Docket Nos. 50-361 and 50-362
Amendment Application Numbers 252 and 238
Proposed Change Number NPF-10/15-583
Replacement Steam Generators
San Onofre Nuclear Generating Station, Units 2 and 3

DESCRIPTION AND NO SIGNIFICANT HAZARDS ANALYSIS FOR PROPOSED CHANGE NPF-10/15-583 PROPOSED TECHNICAL SPECIFICATION CHANGE, REPLACEMENT STEAM GENERATORS San Onofre Nuclear Generating Station Units 2 and 3

Figure 4.2-1 Limiting LOCA (DEHLS with DG Failure) Containment Pressure and Temperatures

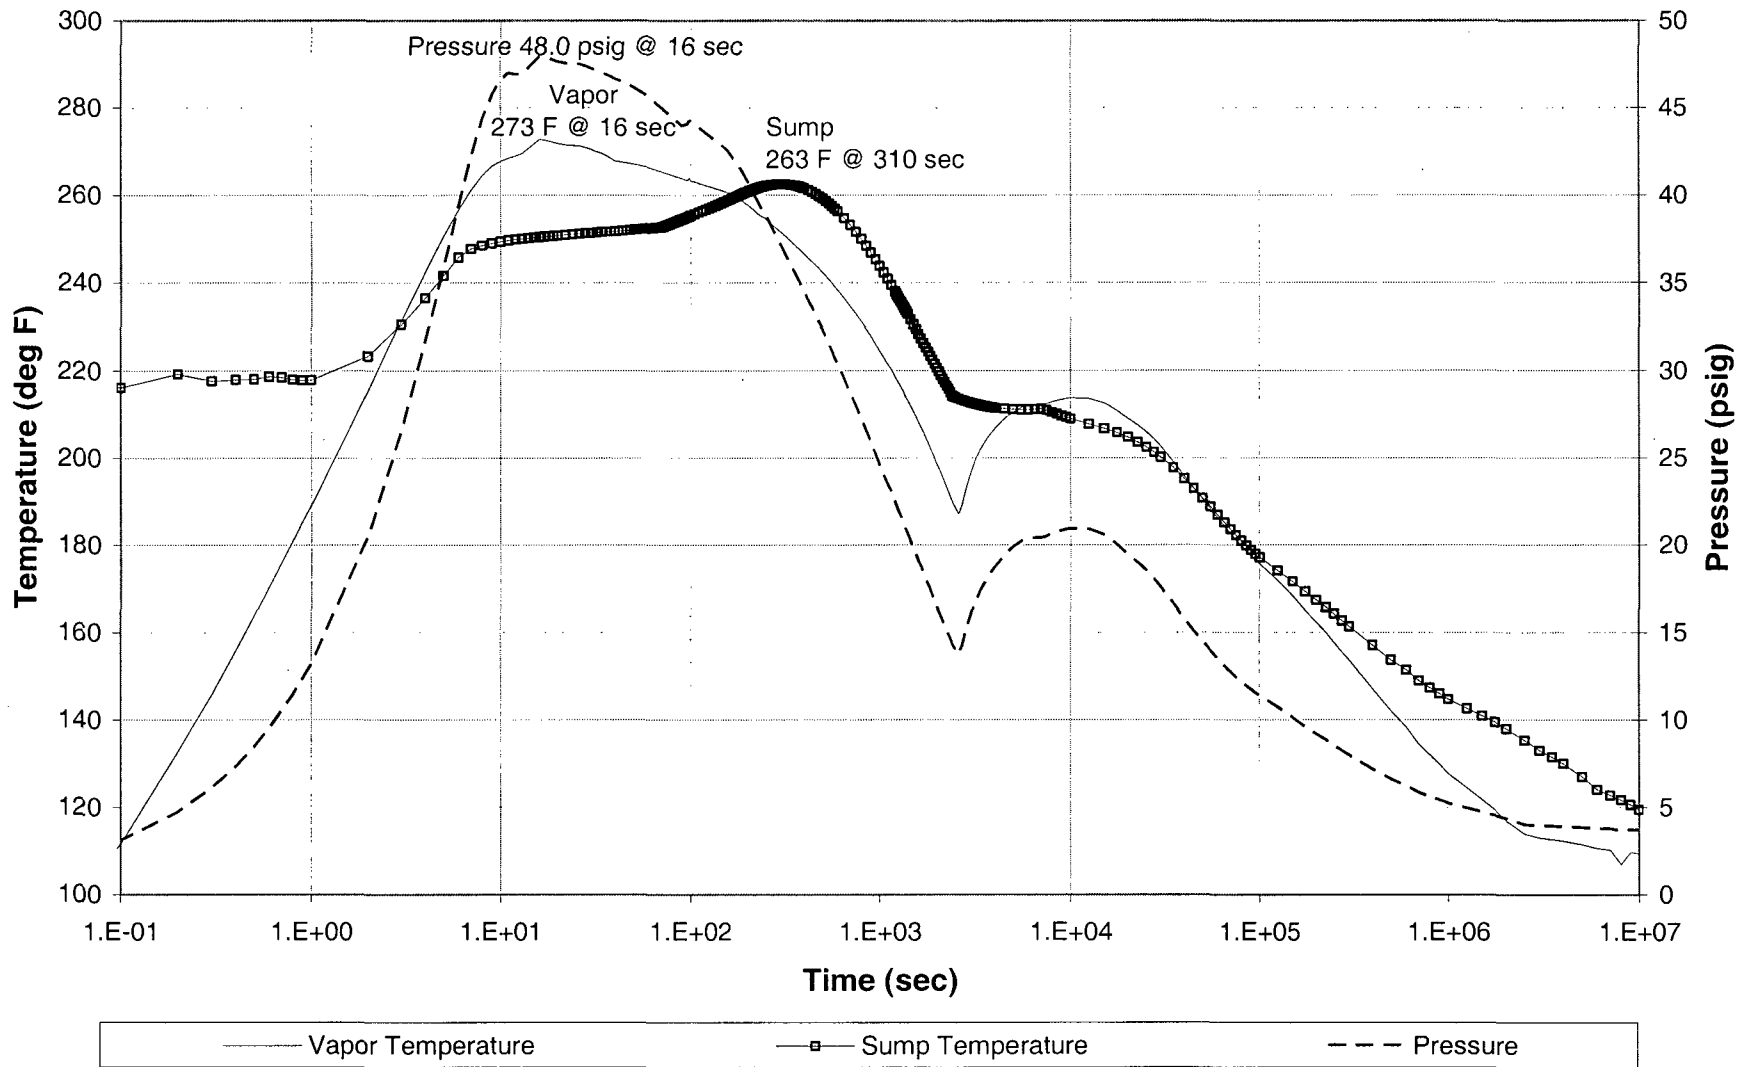
The transient pressure and temperature for the maximum pressure case are shown in Figure 4.2-1. As shown, the containment pressure and temperature peak at a maximum of 48.0 psig and 273°F at 16 seconds, which is before the containment sprays began operation.

The pressure profiles at 24 hours (86,400 seconds) post-LOCA show that the pressure is below half of the peak pressure thereby confirming compliance with GDC 38.

Figure 4.2-3 Limiting MSLB (0% Power with MSIV Failure) Containment Pressure and Temperatures

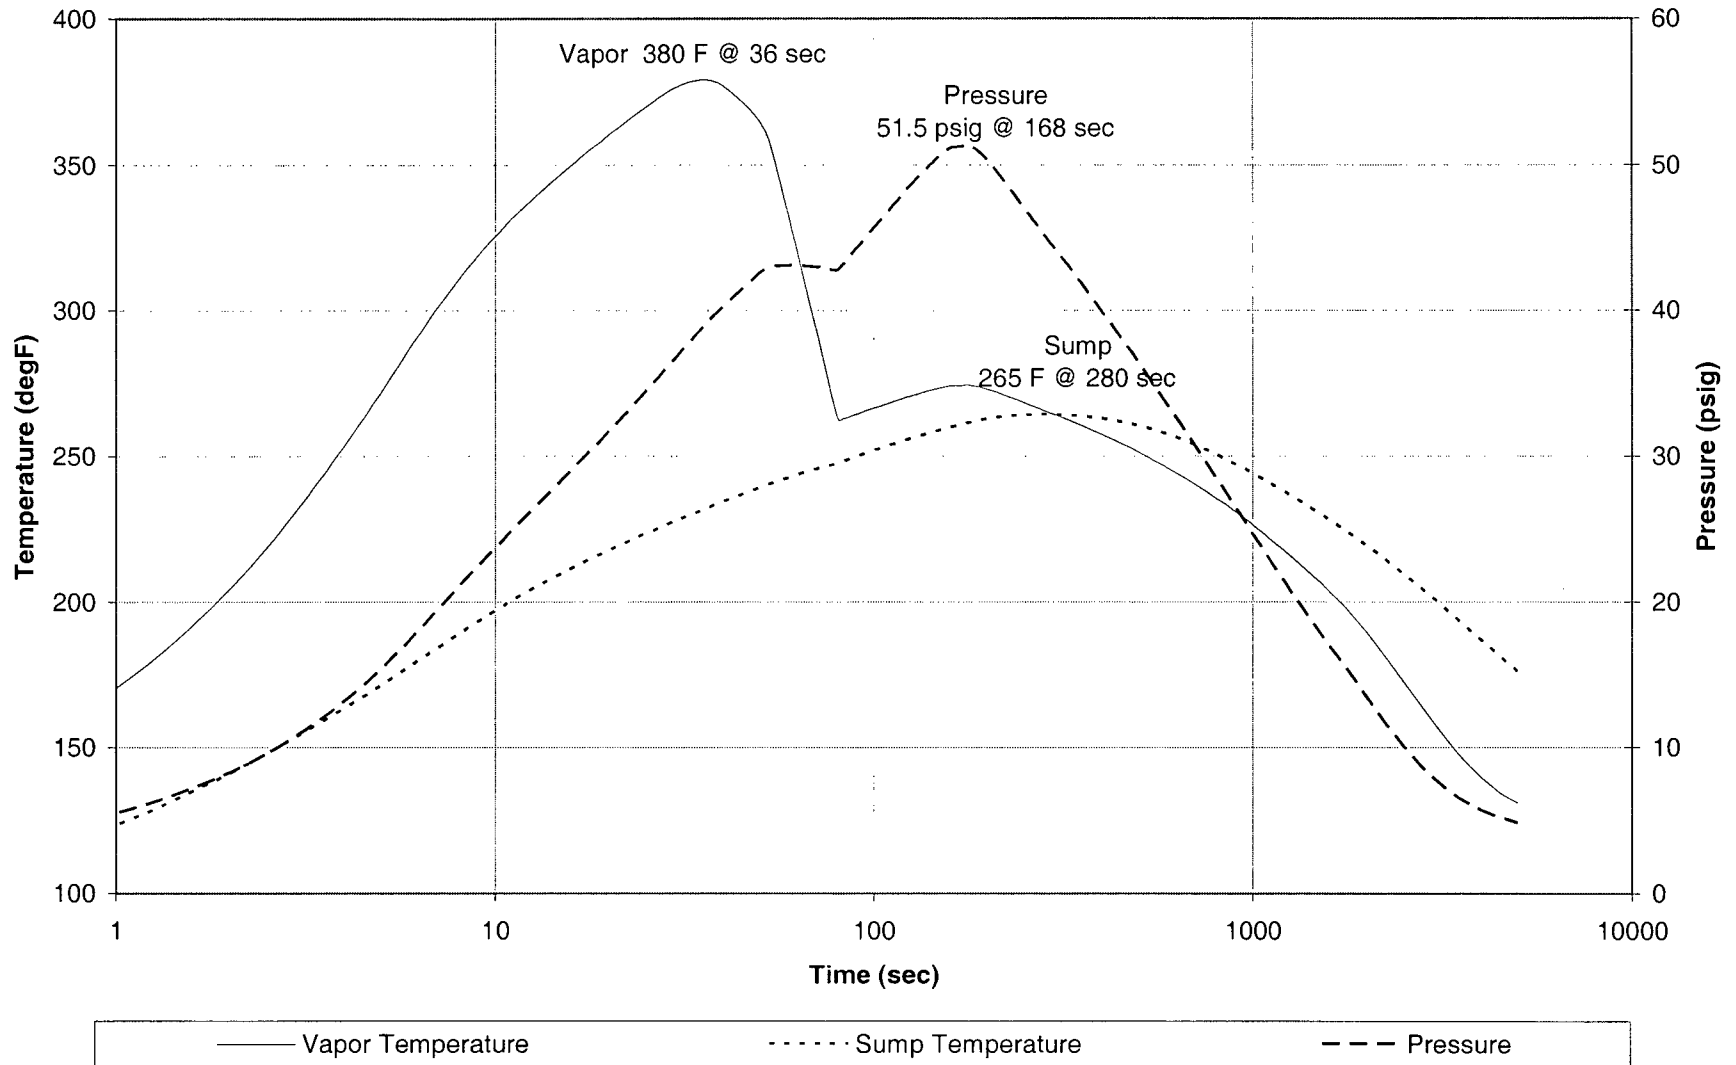
As indicated in the preceding paragraphs, the limiting event was for a MSLB initiated while at 0-percent power, with failure of a MSIV to close. The resulting containment pressure and temperature transient responses are shown in Figure 4.2-3. As shown, the resulting maximum containment atmosphere temperature was 380°F, which occurred at 36 seconds when containment spray flow was ramping to full flow. The figure also shows that the peak pressure was 51.5 psig, occurring at 168 seconds.
